**FINDINGS AND RECOMMENDATION
OFFICE OF PLANNING AND ZONING
ANNE ARUNDEL COUNTY, MARYLAND**

CASE NUMBER: 2024-0050-V

The applicants are requesting variances to allow a dwelling and associated facilities with less setbacks and buffer than required and with disturbance to slopes of 15% or greater on property located at 649 Lakeland Road South in Severna Park.

SHEET 1 OF 1
VARIANCE SITE PLAN

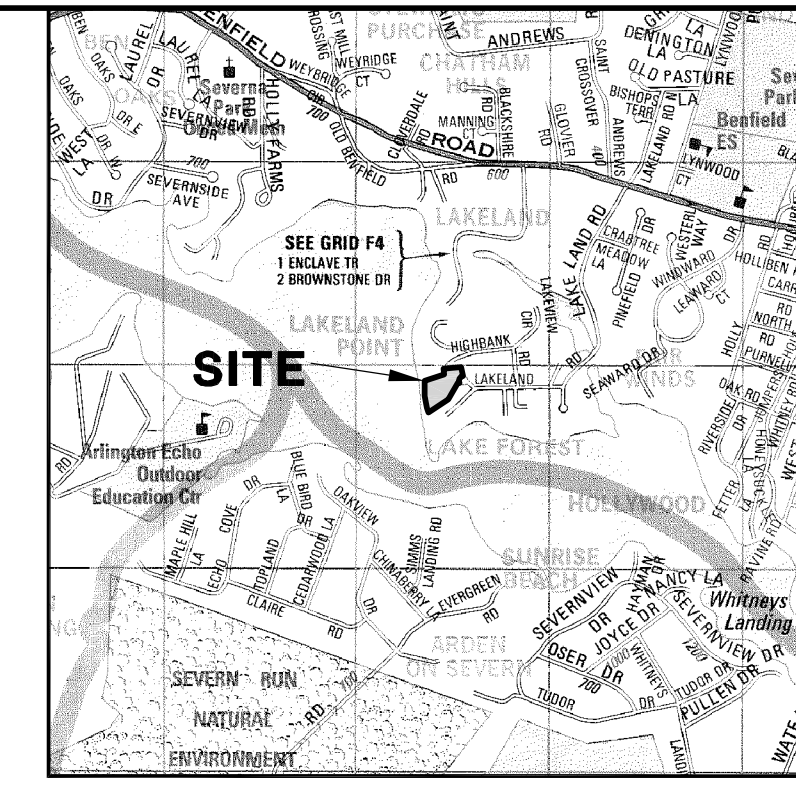
1. label clearly steep slopes and steep slope buffers; per the letter of explanation, there is a disturbance to remove existing improvements; however, this reviewer is not clear on what these disturbances entail as the existing house is shown as a "white background" (i.e., outside of the hatched steep slopes).

2. Per 6.1.4 (G) of the County Stormwater Practices and Procedures manual, SWM facilities shall not be located in areas that are off-limits to development, e.g., natural resource areas and their buffers. The rain gardens are proposed within steep slopes and it is not allowed as proposed.

3. Please provide soil boring on the facility footprint to review the suitability and siting of the proposed facility(ies). Describe the site's hydrologic, and topographic characteristics and provide recommendations on the feasibility of various BMPs.

4. All infiltration/filtration devices shall be located a minimum of 25 feet from the top of slopes 25% or greater and retaining walls. In no case shall the phreatic line from the overflow depth of the device intersect the existing and/or final ground line of the slope or the retaining wall.

5. A soil boring is required per practice. The suitability, and siting of proposed SWM practices should be reviewed. Soil boring information including verification of the suitability of in-situ soils for infiltration shall be submitted.

6. Given the disturbance to sensitive resources including the steep slopes, the proposed design adversely affects the water quality within the Critical Area. Please clarify.

7. Please verify that all of the proposed impervious surfaces are treated for water quality.
8. The County Stormwater manual requires that Infiltration/filtration devices uphill from buildings and structures with basements shall be located a minimum of 20 feet from the structure, or the intersection of the structure foundation footing with the phreatic line from the overflow depth of the device, whichever is greater. Please clarify how this requirement is met.

9. The stormwater management, utility/Engineering design review approval for the site shall occur at the grading permit stage.
10. Based on the above comments and proposed site design, this office does not support this request.
